# Chewton, Slinfold

# Approved and Requested Non Material Amendment Summary

**PROPOSED GROUND FLOOR PLAN**

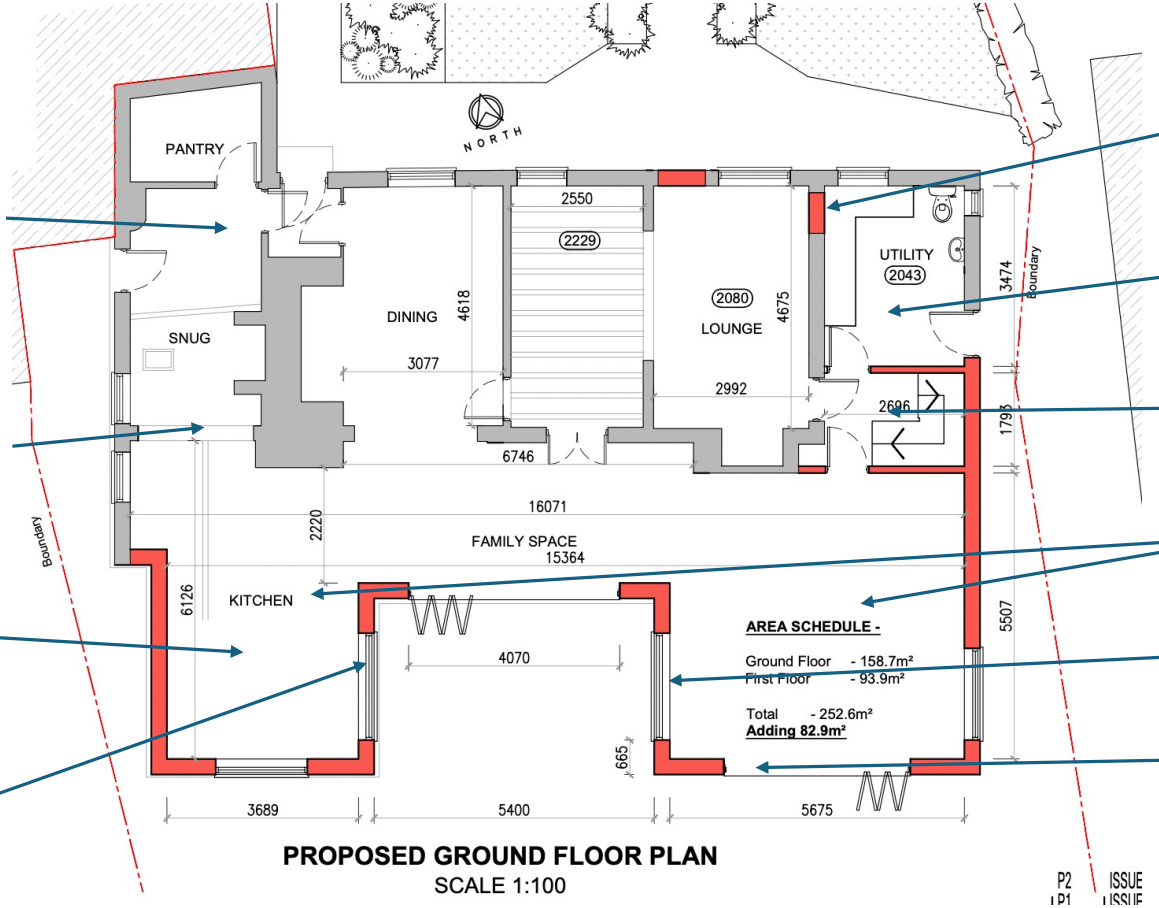
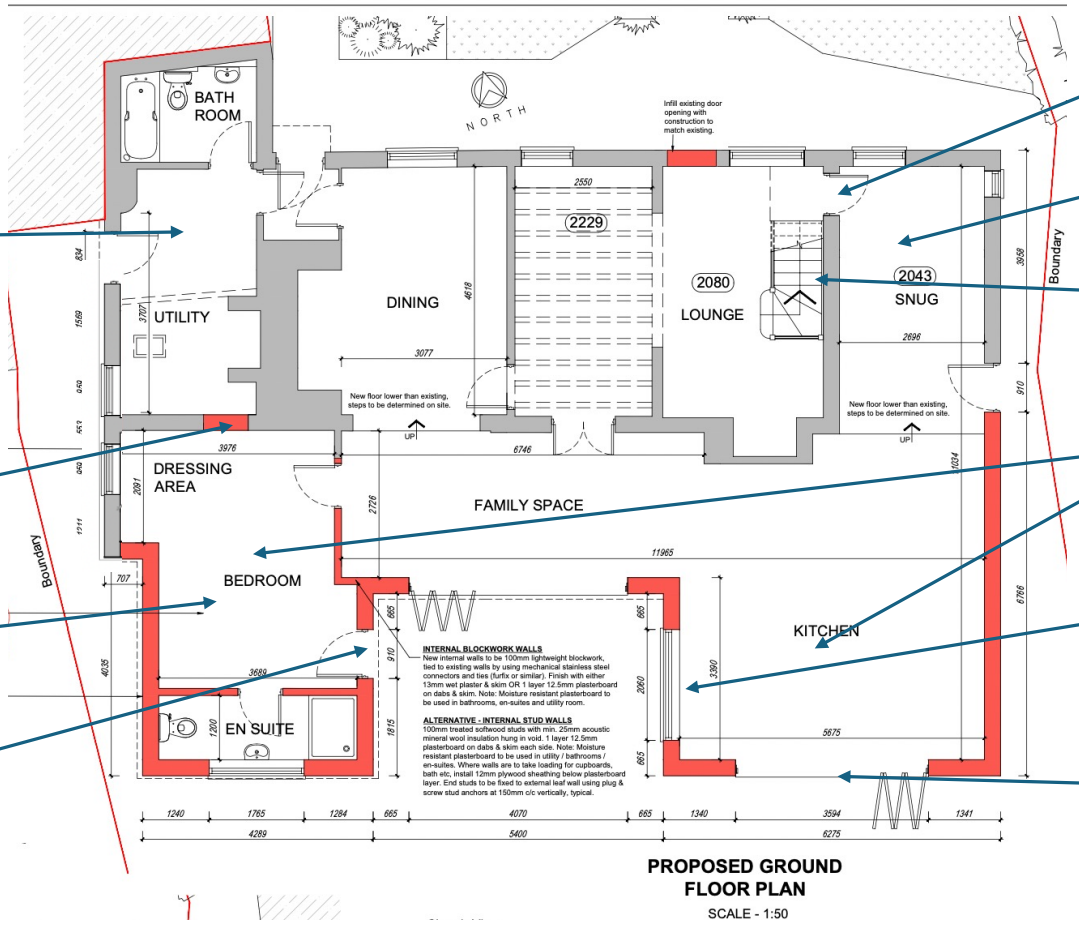
G. Bathroom and Utility moved over to left side

H. Not opening the wall and restoring original wall

I. Replace kitchen with 4th Bedroom/Ensuite due to Upstairs alterations

J. Reduce Opening

A. Keep original door and do not infill

B. Utility and Toilet moved to Snug and Pantry respectively in new layout

C. Keeping Original Stairway location

D. Move Kitchen into Left side on rear

E. Remove Opening

F. Increase Opening from 3.9M to 4.0M

G. Bathroom and Utility moved over to left side

H. Not opening wall – Restoring Original Wall

I. Replace kitchen with Bedroom #3/Ensuite due to Upstairs alterations

J. Reduce Opening

A. Keeping original door and no infill

B. Utility and Toilet switched with Snug and Pantry

C. Keeping Original Stairway location

D. Switched Kitchen for Bedroom and Ensuite

E. Remove Window

F. Increase Opening from 3.9M to 4.0M

# Submitted and Approved Version – First Floor

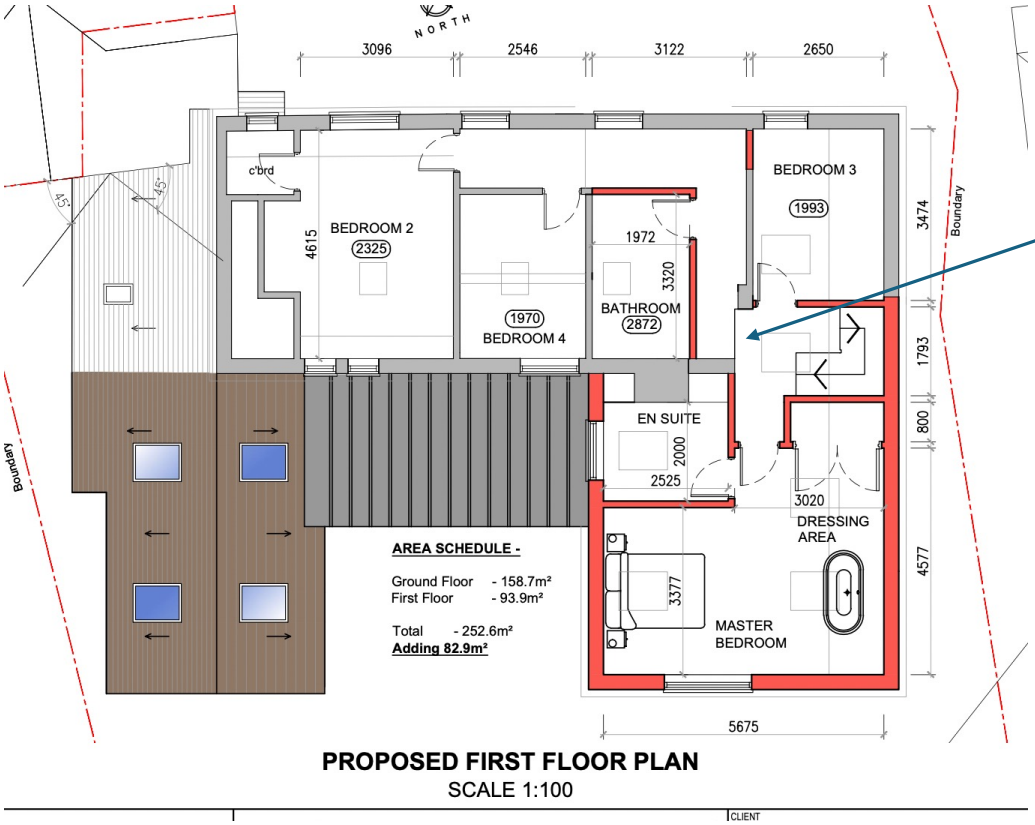
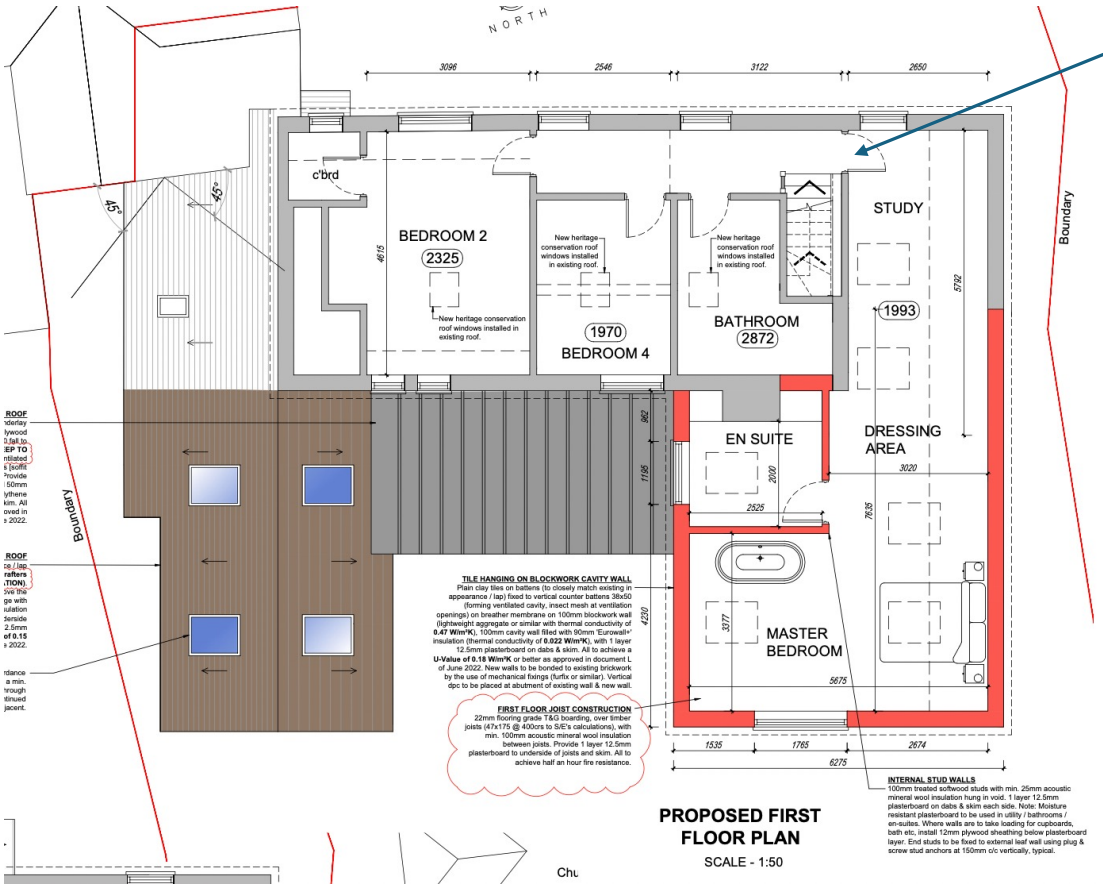
A. New stairway required cutting into main structural oak beam to create new corridor – keep original stairs and corridor to maintain historic structure

A. Keeping original bathroom, access door and stairway. Results in loss of upper bedroom #3 and replace with ground floor bedroom #3

Note: Property is still 4 bedrooms pre and post variance
